<b>DEVELOPMENT NO.:</b>	23009317
<b>APPLICANT:</b>	Alexandra Stadtkus / Enzo Caroscio
<b>AGENDA ITEM NO:</b>	3.2
<b>ADDRESS:</b>	112-114 Gilles Street, Adelaide SA 5000
<b>NATURE OF DEVELOPMENT:</b>	Demolition of existing buildings and construction of three (3) four storey dwellings in a terrace arrangement
<b>ZONING INFORMATION:</b>	<p><b>Zones:</b></p> <ul style="list-style-type: none"> <li>• City Living</li> </ul> <p><b>Subzones:</b></p> <ul style="list-style-type: none"> <li>• Medium-High Intensity</li> </ul> <p><b>Overlays:</b></p> <ul style="list-style-type: none"> <li>• <del>Airport Building Heights (Regulated)</del></li> <li>• Affordable Housing</li> <li>• <del>Building Near Airfields</del></li> <li>• Design</li> <li>• Heritage Adjacency</li> <li>• Hazards (Flooding - Evidence Required)</li> <li>• <del>Regulated and Significant Tree</del></li> <li>• Stormwater Management</li> <li>• Urban Tree Canopy</li> </ul> <p><b>Technical Numeric Variations (TNVs):</b></p> <ul style="list-style-type: none"> <li>• Maximum Building Height (14 Metres)</li> <li>• Minimum Building Height (2 Levels)</li> <li>• Maximum Building Height (4 Levels)</li> <li>• Minimum Site Area (Minimum site area

**Figure 9.5.2 – Western elevation/side boundary**

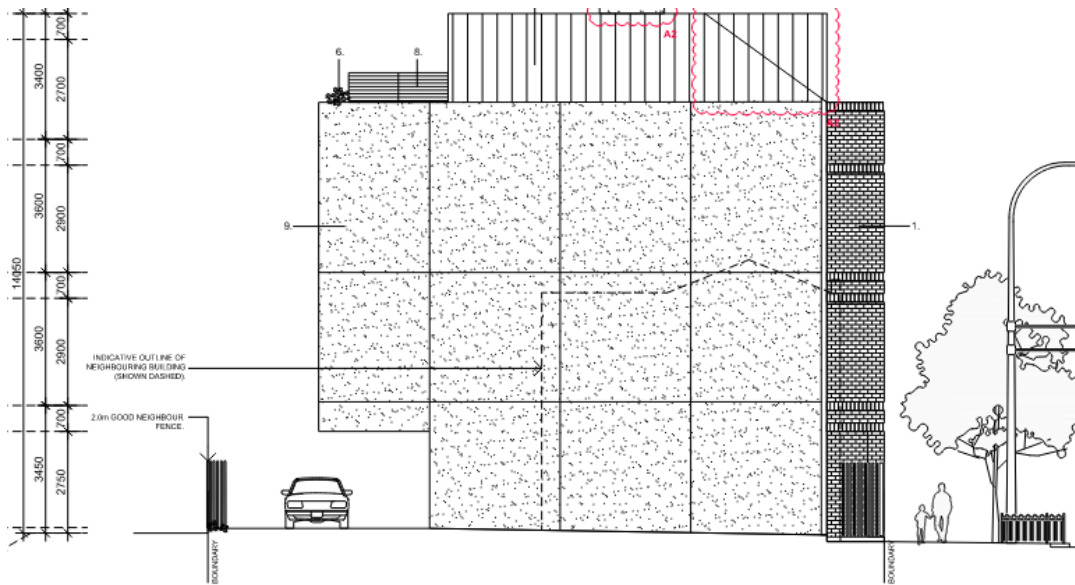
Figure 9.5.2 depicts proposed boundary walling which appears imposing on 110 Gilles Street in plan view. However, much of the wall will not be visible from outdoor areas and will only receive negligible shadowing during morning hours. The proposed side setback is considered to conform to established side boundaries in the locality. Whilst the extent of boundary wall extends beyond abutting wall, consequential amenity impacts via visual bulk and overshadowing on neighbours will be limited, thus satisfying CLZ PO 3.2 and PO 3.5.

**Figure 9.5.4 – Overlooking sections**

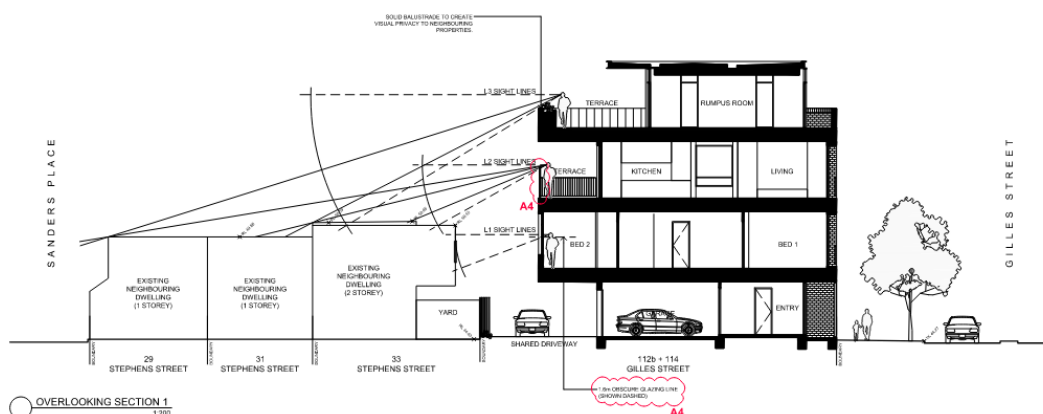
Concerns of overlooking have been raised by representors to the north and east of the development. The first involves concerns of views from the proposed roof terrace at 114 Gilles Street into the roof terrace at 122 Gilles Street. This property is located on the opposite side of Stephens Street. Potential for overlooking across the public realm is not addressed in the Code. It is considered further screening would exacerbate the overall building height and limit opportunities for passive surveillance, which is desired for street facing windows and balconies.

Other concerns have been expressed by occupants at 23 Stephens Street, which has private open space areas and habitable room windows at the ground and first floors adjacent the subject site. Obscured glazing is proposed to height of 1.6 metres for north facing windows at Level 1 and 1.6 metre high obscured balustrading for the Level 2 terraces. Fully obscured glazing is proposed for the powder room glazing.

The roof level terraces at Level 3 will have in-built planters with a minimum dimension of 900mm and height of 1 metre, thus limiting ability to look down into proximate private open space areas. Together these treatments will prevent 'direct overlooking' that could otherwise be achievable as demonstrated in Figure 9.5.4 below.
